REGIONAL REVIEW NOTIFICATION

ARC REVIEW CODE: R1912101

Name of Proposal: Huber Street Ready-Mix Concrete Plant (DRI #2934)

HUBER STREET READY-MIX DRI
City of Atlanta
Natural Resources Group Review Comments
December 6, 2019

SITE CONCEPT PLAN

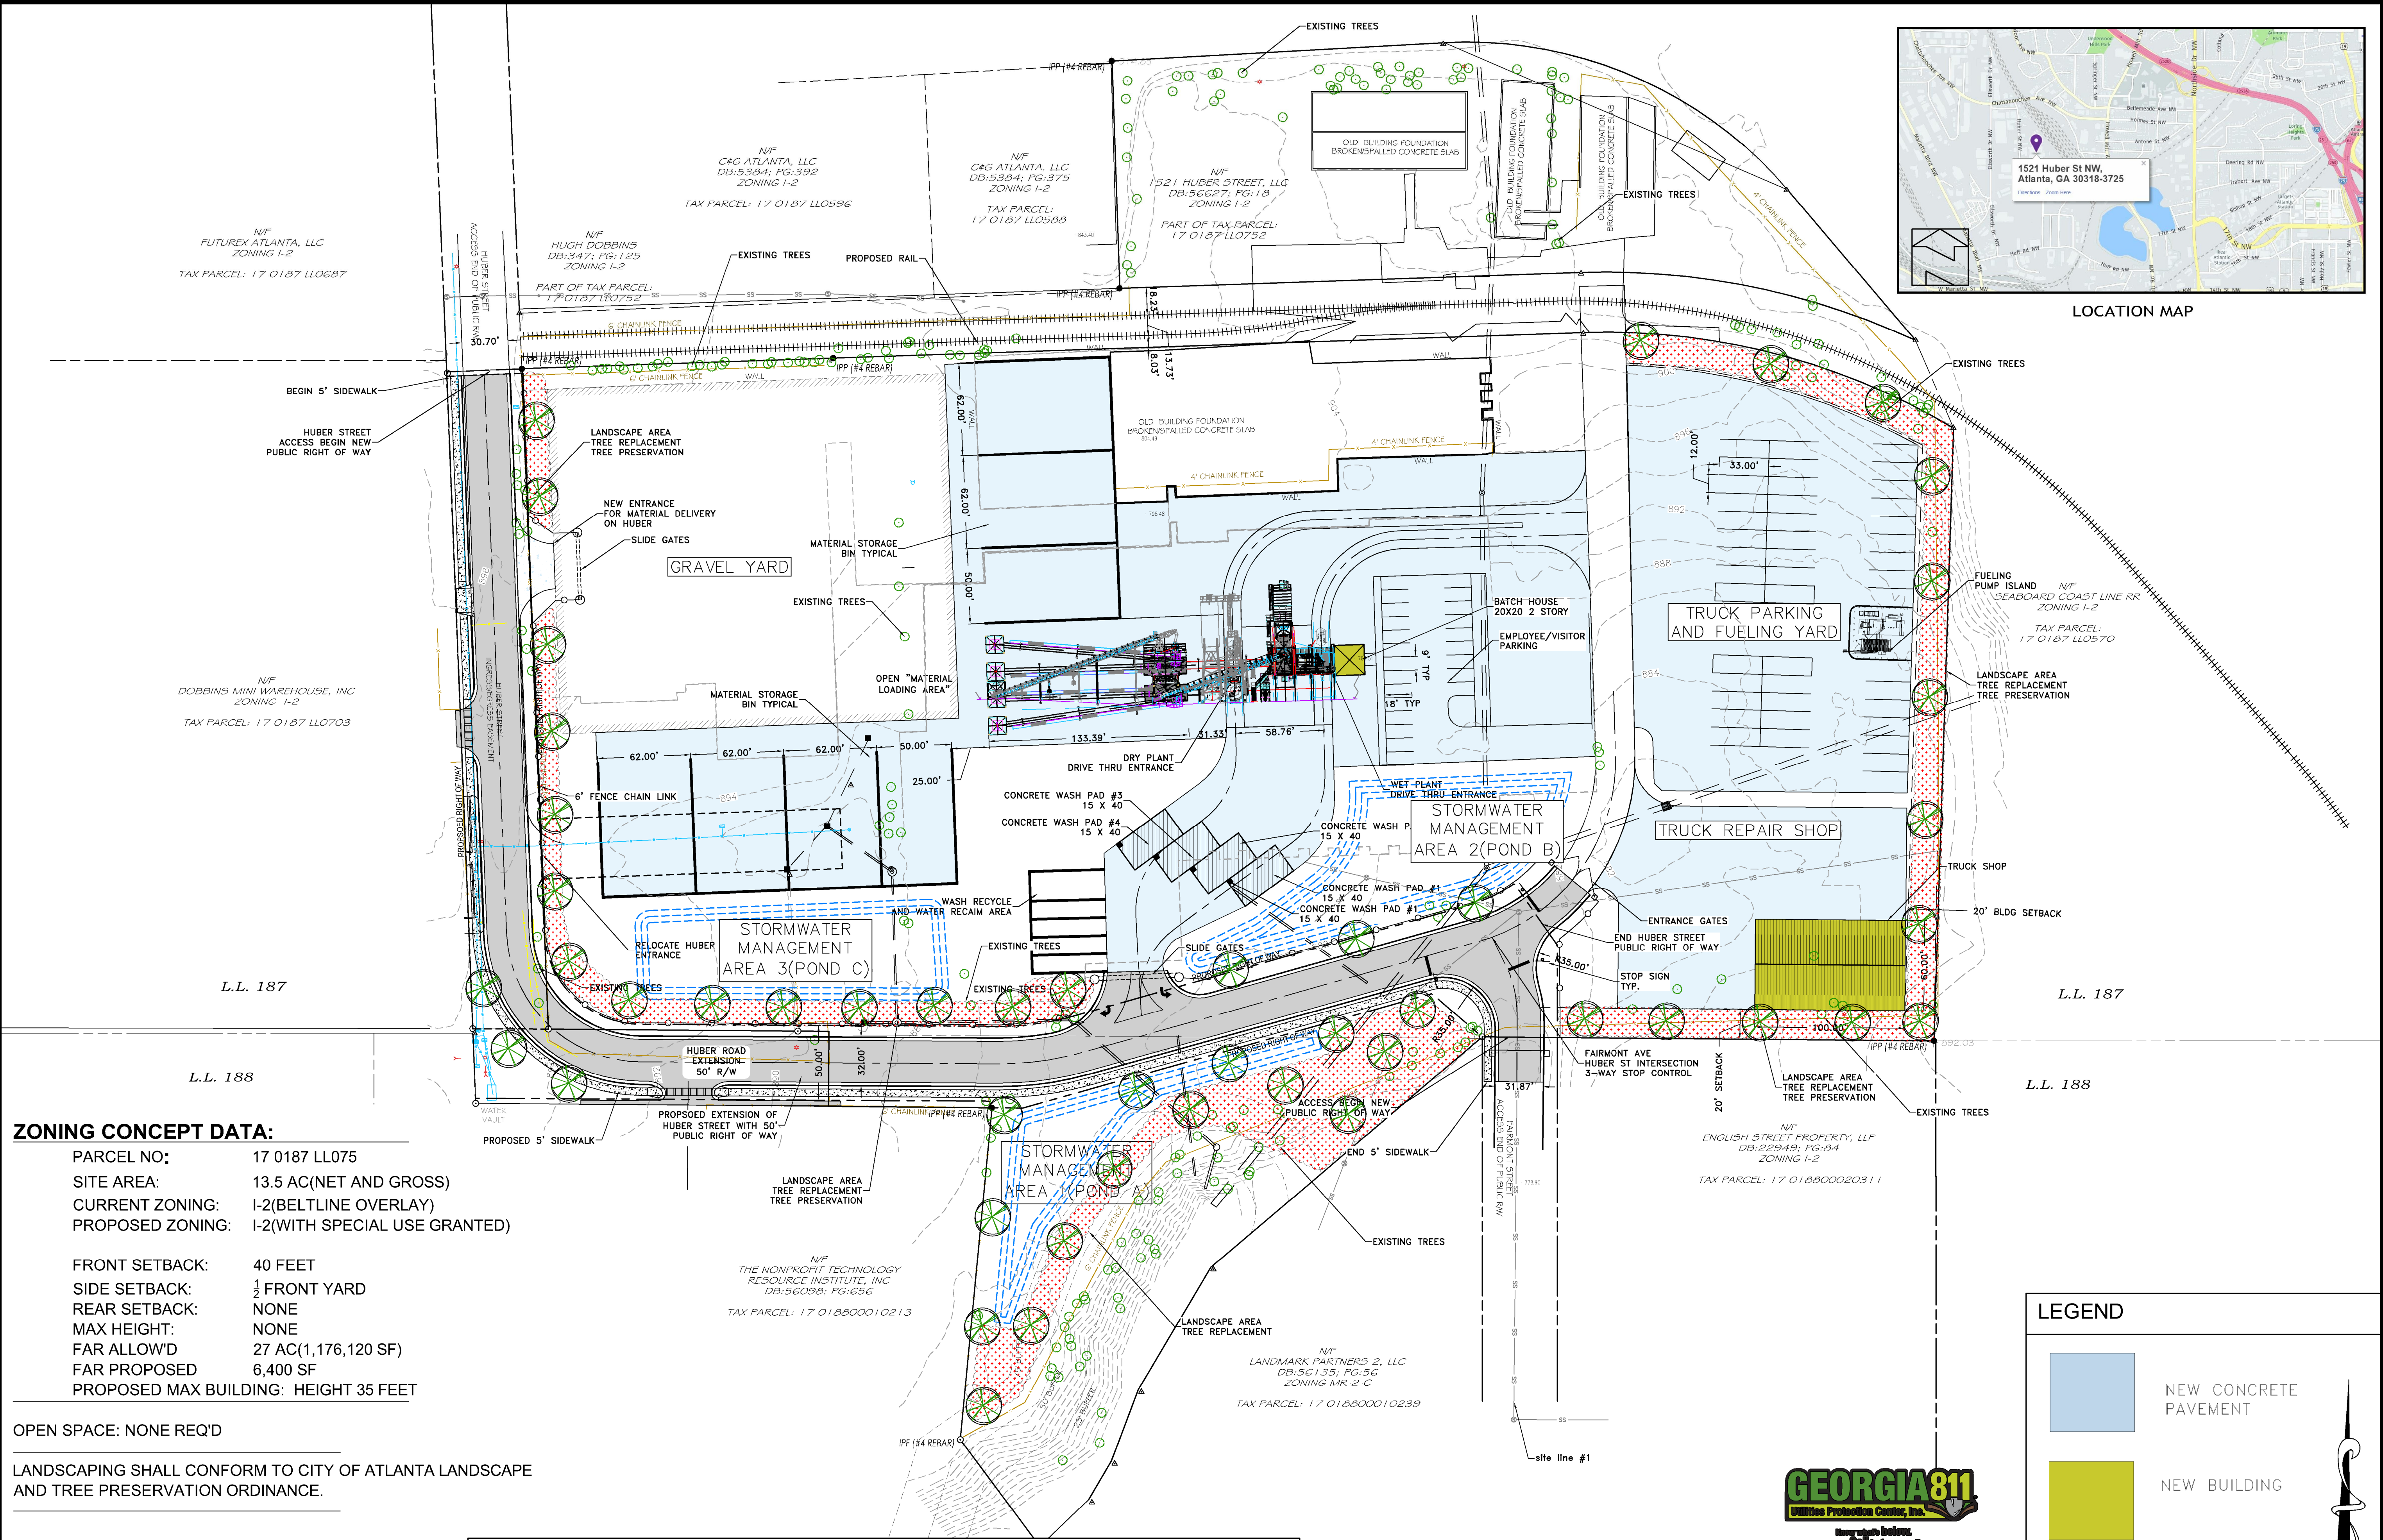
project area shows no blue line streams on or near the project property, and no streams are shown on the submitted site plan. Any unmapped streams on the property may be subject to the City of Atlanta's Stream Buffer Ordinance. Any waters of the state that may be on the property will also be subject to the State 25-foot erosion and sedimentation buffer requirements.

Although vehicle traffic is expected to be very low, vehicles appear to share common drive access with trucks entering and exiting the site.
